SUBJECT: Forwards responses to NRC 830118 request for info re accident monitoring, to aid in post-implementation review of NUREG-0737, Items II.F.1.4, II.F.1.5 & II.F.1.6.

Re: St. Lucie Unit 1  
Docket No. 50-335  
Post TMI Requirements  
Additional Accident Monitoring Information

RE: ST. LUCIE UNIT 1  
DOCKET NO. 50-335  
POST-TMI REQUIREMENTS  
ADDITIONAL ACCIDENT MONITORING INFORMATION

FIGURE 1

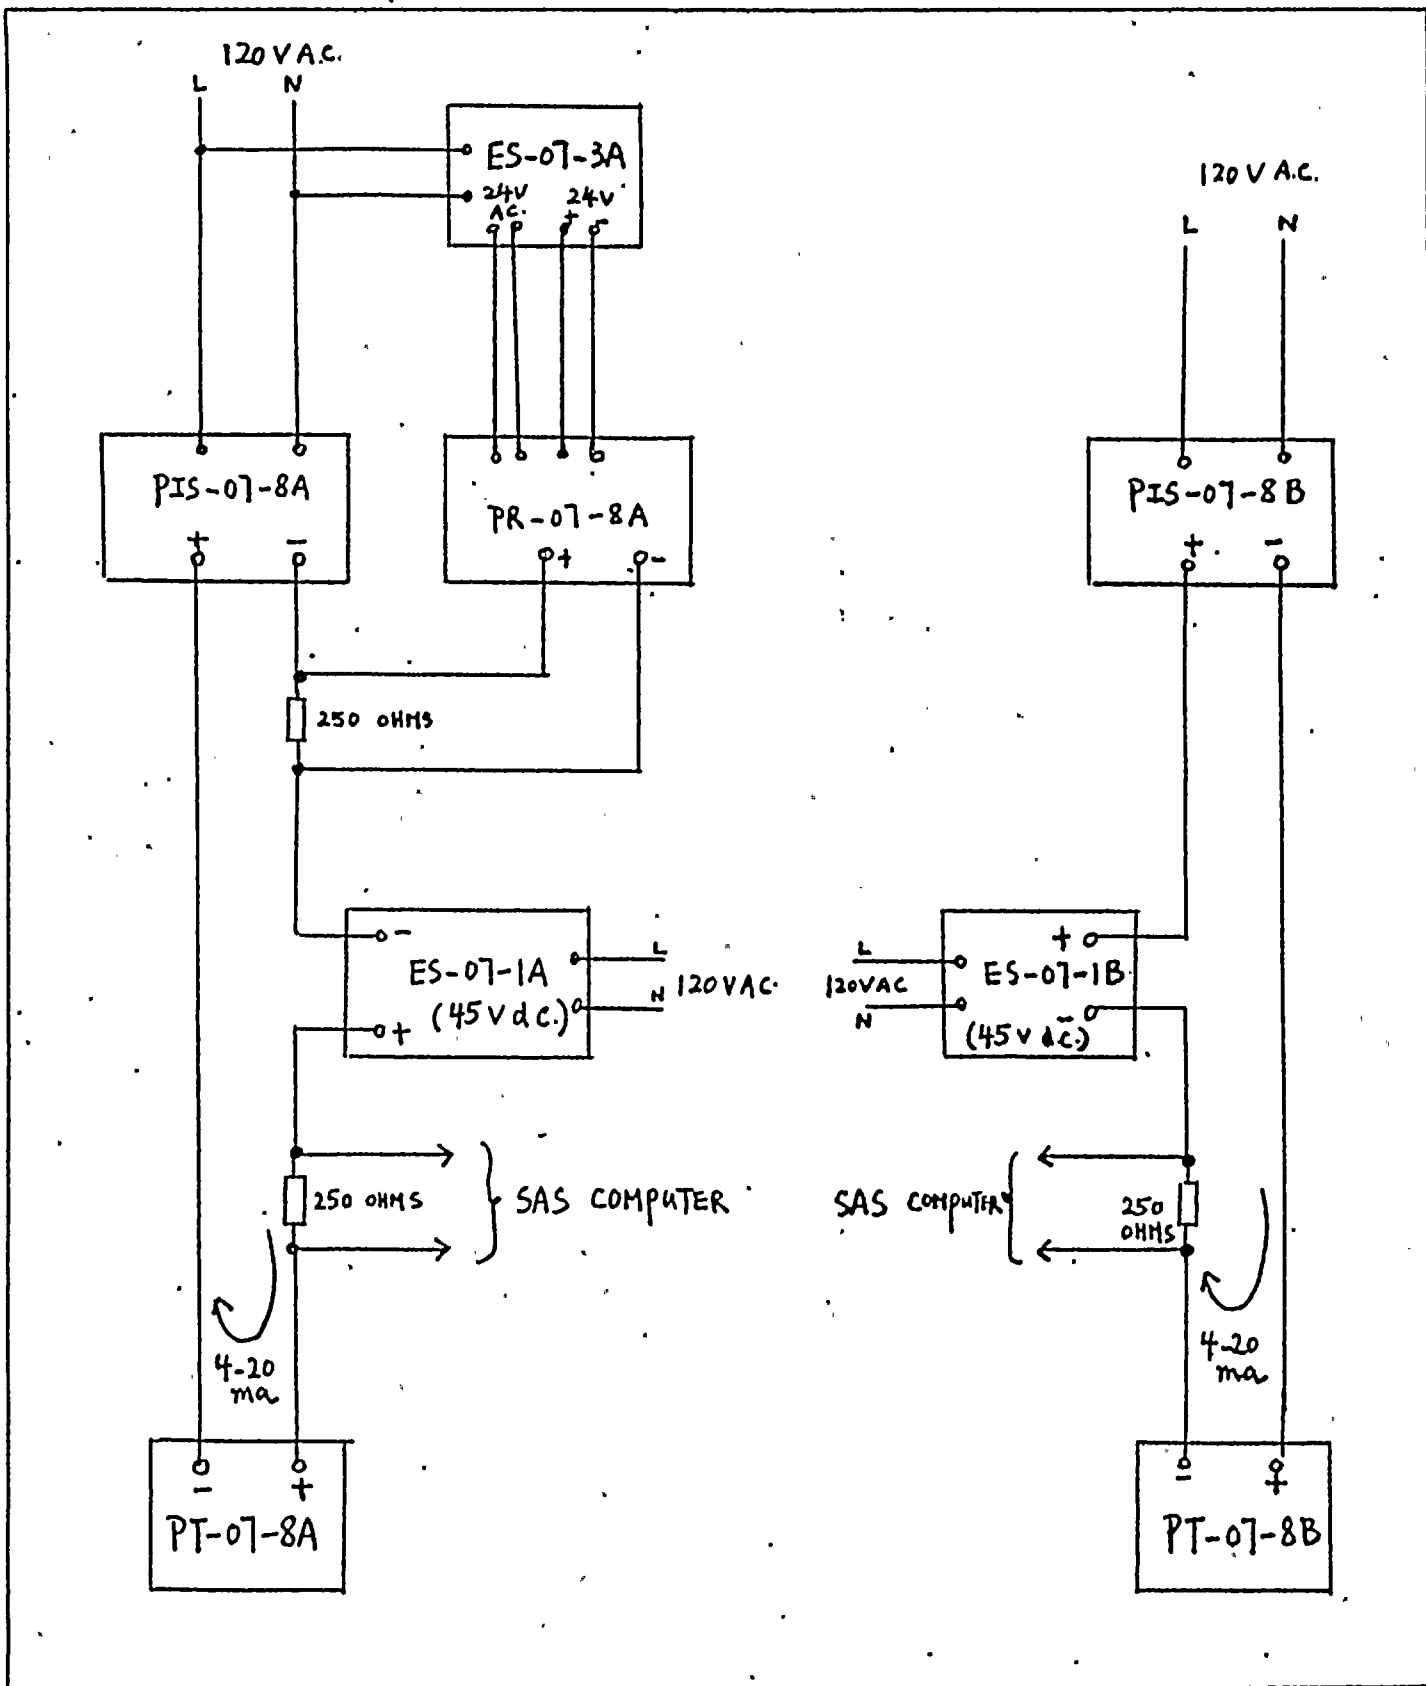
- 2a) The Containment Pressure Monitor System block diagram with the equipment number for each module noted is provided in Figure 1. The manufacturer and model number of each module are listed in Attachment 1.

FIGURE 3

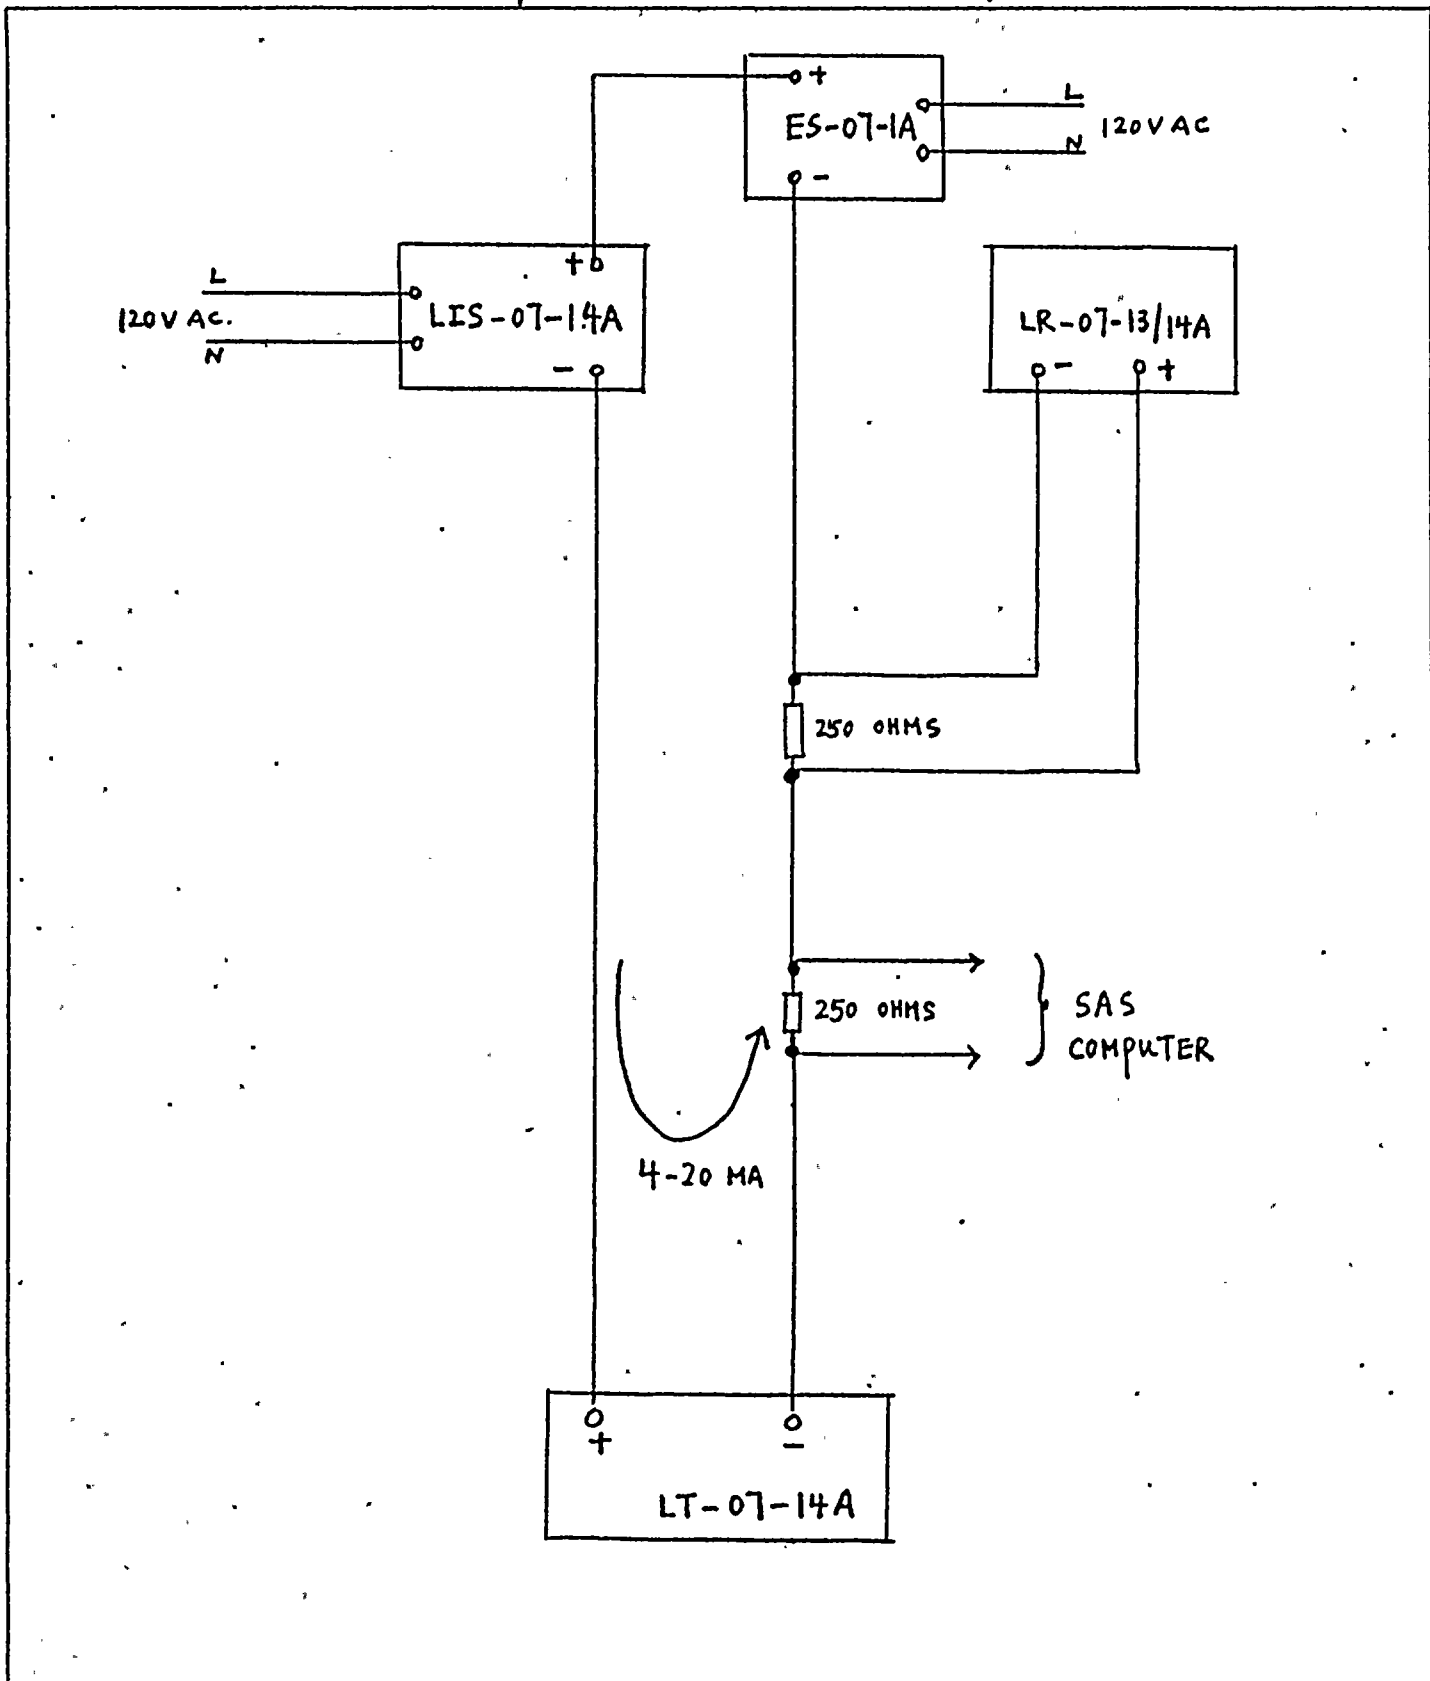
- 3a) The Containment Level (wide range) Monitoring System block diagram is shown in Figure 2 and the Containment Sump Level (narrow range) Monitoring System block diagram is shown in Figure 3. The manufacturer and model number of each module are listed in Attachments 2 and 3.
- 3b) Attachments 2 and 3 provide the range and accuracy for each module of the two level monitoring systems.
- 3c) The individual module parameters were used to calculate (using the square root of the sum of the squares) the overall loop indicating and recording accuracies for both the wide range and narrow range level monitoring systems. These accuracies are listed in Attachments 2 and 3.

FIG. 4

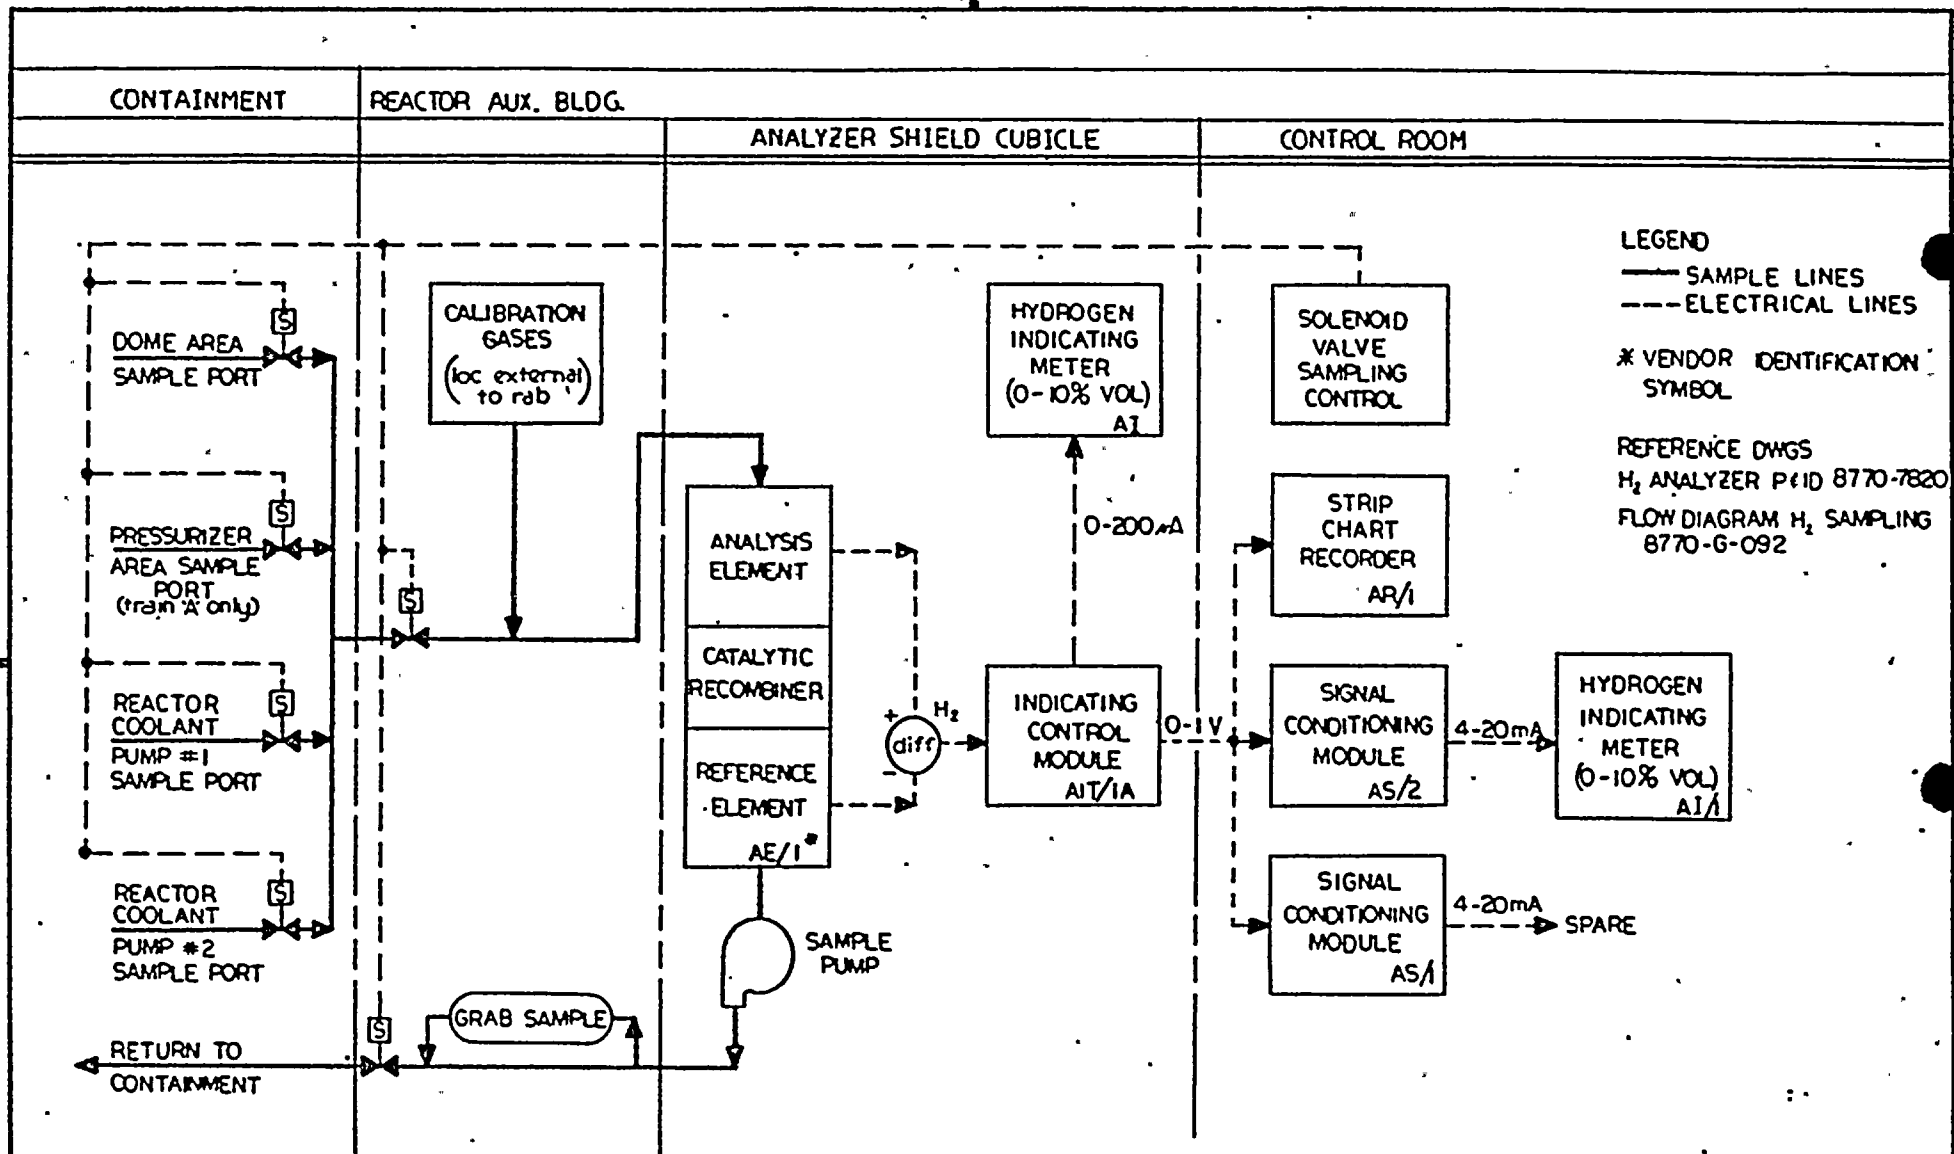
- 4a) The Hydrogen Analyzer Monitoring System block diagram is shown in Figure 4.
- 4b & 4c)

FIG. 5

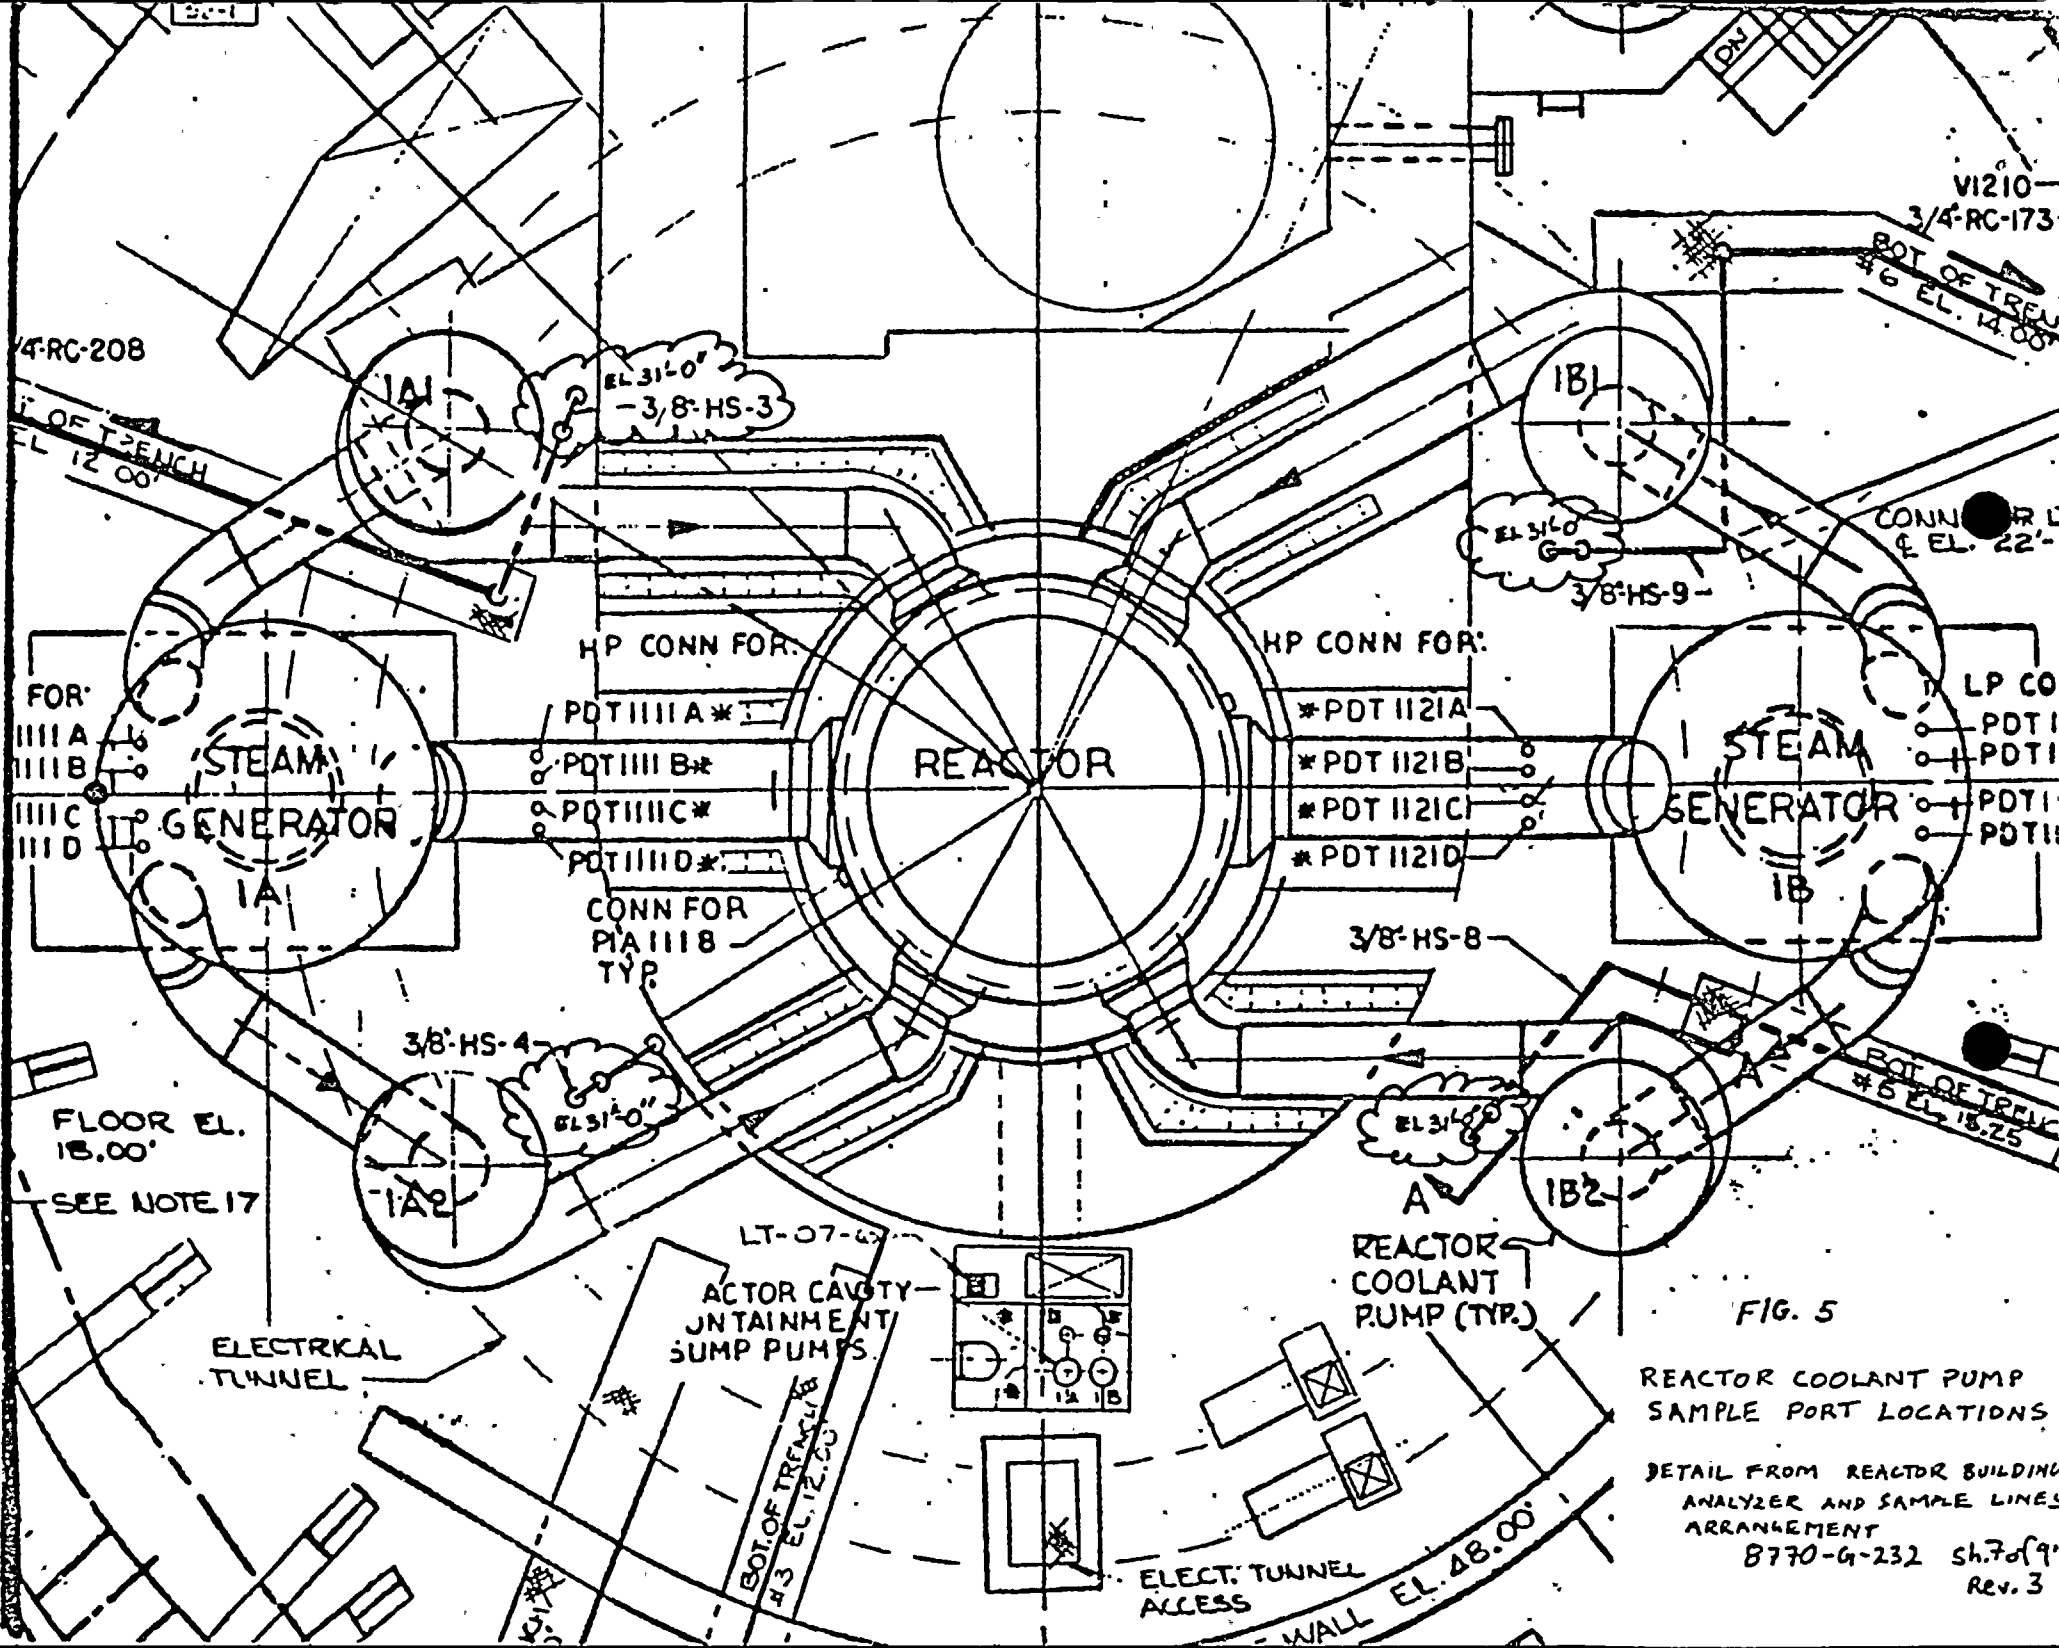
4d) The placement of the seven (7) hydrogen monitor intake ports are listed in Attachment 5.

4e) An in-containment inspection of the sample ports was performed on April 19, 1983 as part of a system walk down. Site support engineers (I&C) visually inspected the sample ports and verified the absence of any physical barriers that would obstruct the hydrogen flow path to the sample ports.
